INFORMATION REQUEST RESPONSE

RESPONSE TO INFORMATION REQUEST – 35 NUNDAH STREET, NUNDAH (APPLICATION REFERENCE - A007068121)

Figure 2: The letterbox location below.

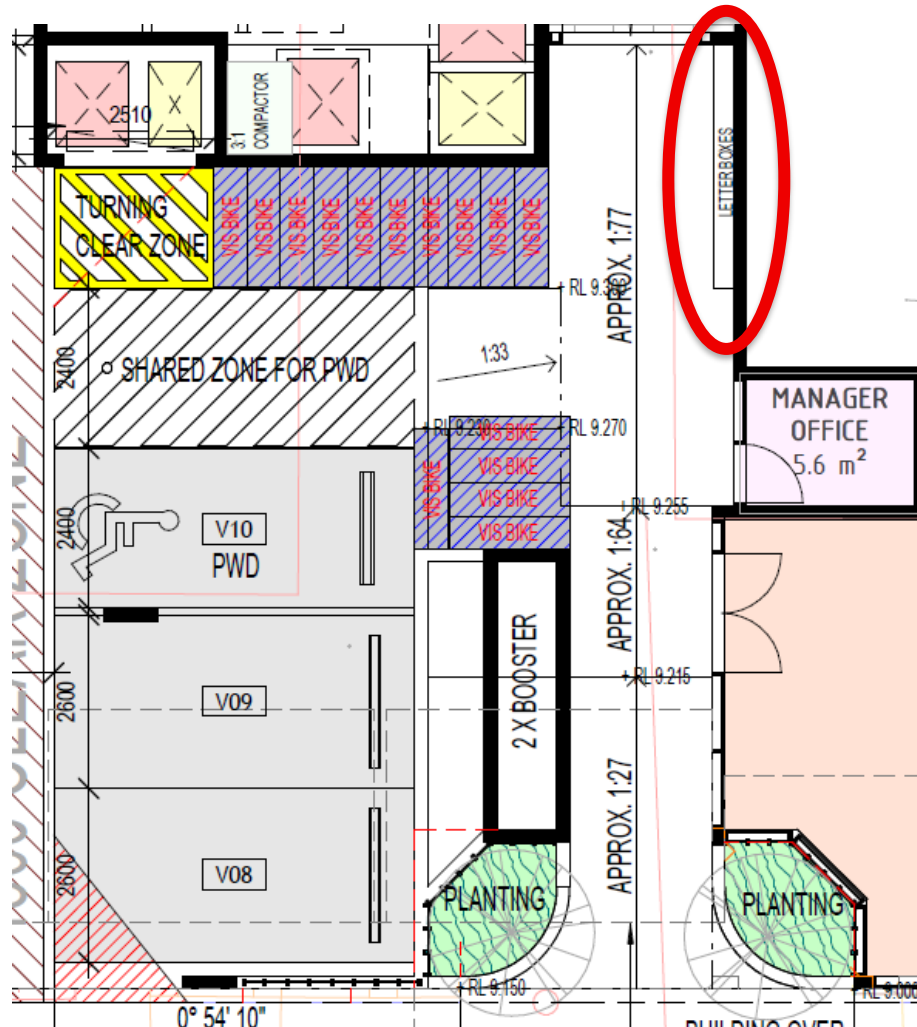
14) Nominate a location for the residential letterboxes. The future location of this element should be integrated with the active frontage requirements as noted AO12.2 Multiple dwelling code.

a) Provide amended plans to indicate letterbox location.

Letterboxes have been incorporated at the entrance of the foyer, as shown in Figure 2 below:
